TRANS/WP.29/671

Working Party on the Construction of Vehicles

DRAFT SUPPLEMENT 4 TO REGULATION No. 43

(Safety glazing)

"Rigid plastic glazings other than windscreens

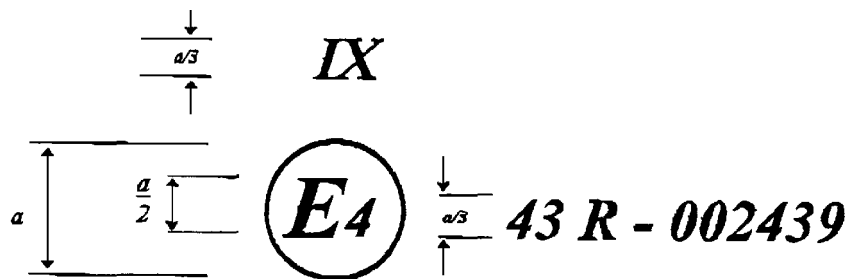
In addition, add at the end of this annex three new examples of approval marks, to read:

The above approval mark affixed to a rigid plastic glazing pane for forward facing panels shows that the component concerned has been approved in the Netherlands (E 4) pursuant to Regulation No. 43 under approval No. 002439. The approval number indicates that the approval was granted in accordance with the requirements of Regulation No. 43.

Figure 2.1

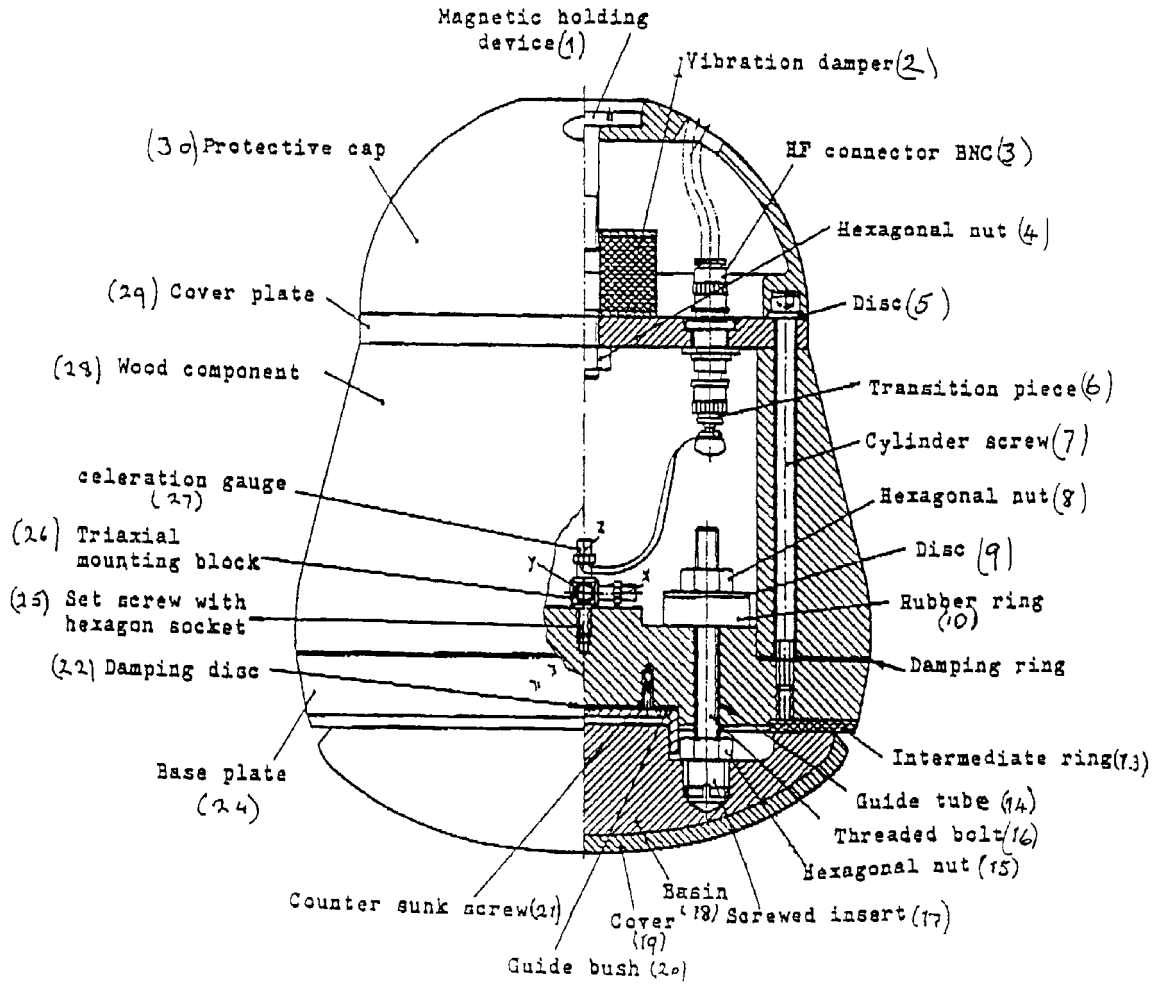
In the case of headform tests with simultaneous determination of HIC-values the drop body is the phantom head as in figure 2.1. The total mass of the phantom head should be  $10.0 \pm 0.2/-0.0$  kg.

In the middle of the base plate (24) the triaxial mounting block (26) is mounted in the centre of gravity to receive the acceleration gauges (27). The acceleration gauges should be arranged vertically to each other.

The basin (18) and cover (19) situated under the base plate (24) share, to a great extent, the elastic properties of the human skull. The elastic properties of the phantom head on impact are determined by the hardness and the thickness of the intermediate ring (13) and the basin.

Figure 2.2

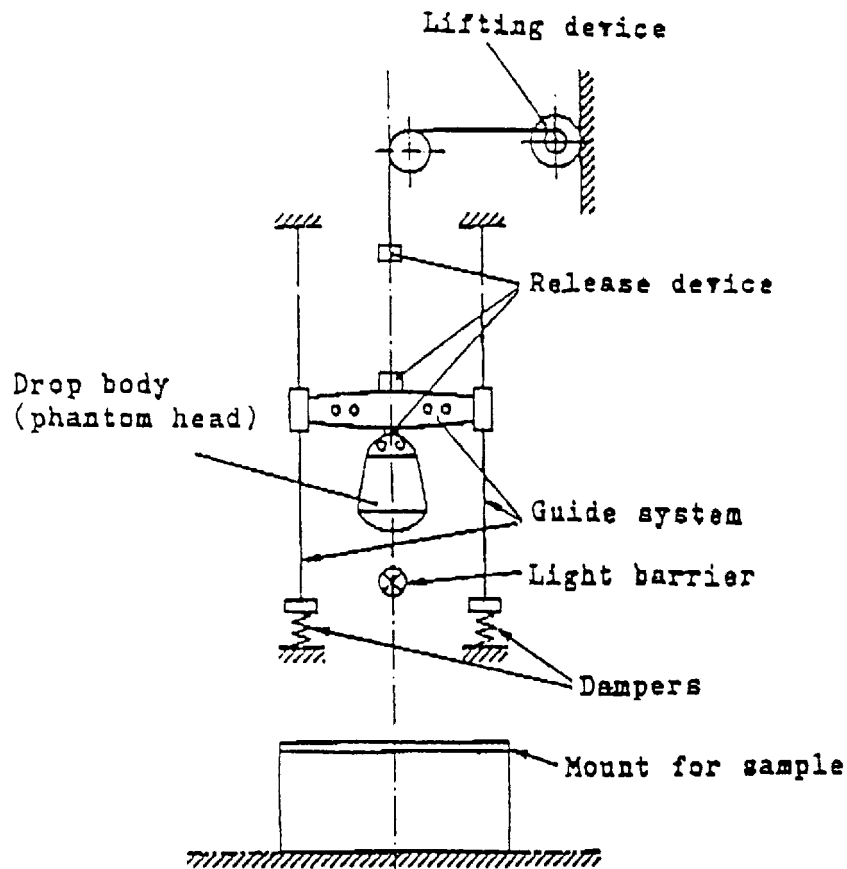
To perform the headform test the phantom head is fixed to the cross arm of the guide system (figure 2.2) and moved to the required drop height by means of a lifting device. During the headform test the cross arm with the phantom head is released. After passing the height adjustable light barrier the phantom head is released from the cross arm, the cross arm's fall is dampened and the phantom head falls onto the sample.

No impulse may be given to the phantom head by the drop appliance or by the measuring cable, so that it is accelerated only by gravity and falls vertically.

Figure 21: Method of setting up the test specimen

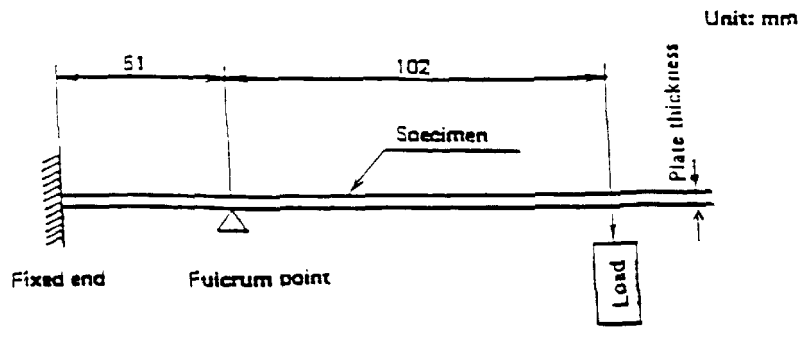
11.2.1.1. The test specimen shall be simply supported as a horizontal level arm between a fixed supporting edge at one end in such a way that the entire width will rest on a cutting edge (fulcrum) which is 51 mm from the fixed end support. A load shall be suspended from the free end of the test specimen at a distance of 102 mm from the fulcrum as shown in figure 21 below:

11.2.1.2. The load mass shall be  $28.7 t^2$  g where  $t$  is the thickness in mm of the test specimen. The resulting stress on the outer fibre of the test specimen is approximately 6.9 MPa.

Figure 22 : Method of Applying Chemicals to the Test Specimen

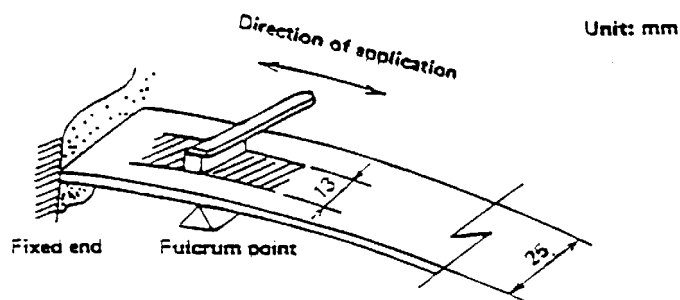
- 11.2.1.3. While the test specimen is stressed, one of the prescribed chemicals shall be applied to the top surface of the test specimen above the fulcrum point. The chemical shall be applied with a soft, 13 mm wide brush, wetted before each stroke. Ten individual strokes at 1 s intervals across the width of the test specimen, avoiding the end and edges, shall be required (see figure 22).

Figure 23 : Arrangement of flexibility test

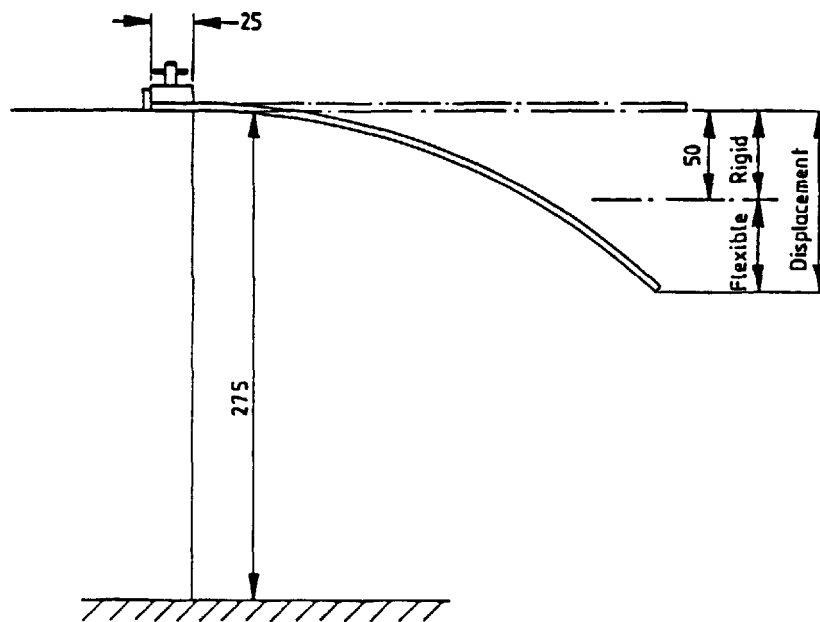
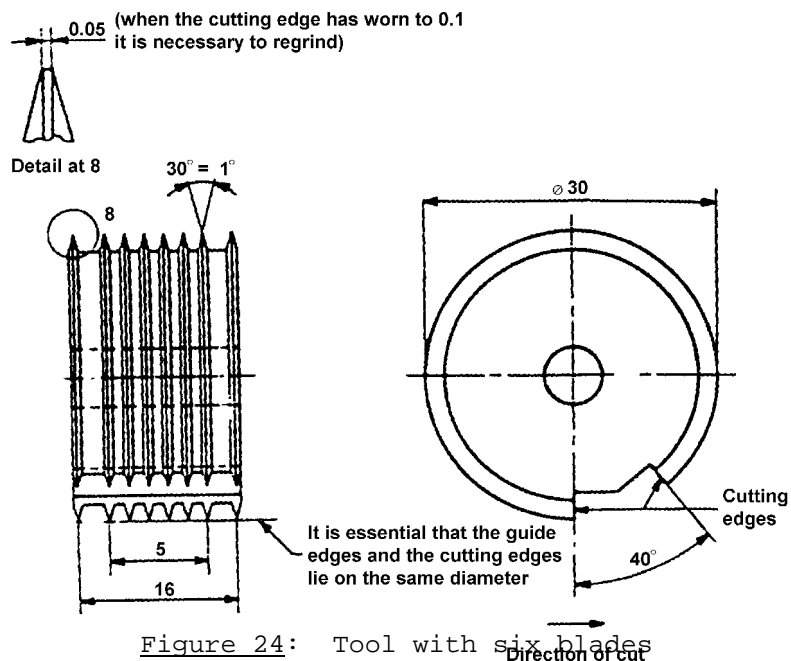
From the material of the nominal thickness a rectangular flat sample 300 mm long and 25 mm wide is cut out and horizontally clamped into a clamping device in such a way that 275 mm of the length of the sample freely extend over the holding device. This free end shall be supported horizontally by an appropriate device until the test begins. 60 seconds after removal of this support the vertical deviation of the free end is indicated in mm. If this deviation exceeds 50 mm a 180° fold test is performed subsequently. The sample is folded concisely, after that it is folded round 0.5 mm thick piece of sheet metal in such a way that

The vertical deviation must be more than 50 mm for flexible plastics, and 10 seconds after a  $180^{\circ}$  - folding the material must not show any fracture-like damages at the point of buckling (see figure 23).
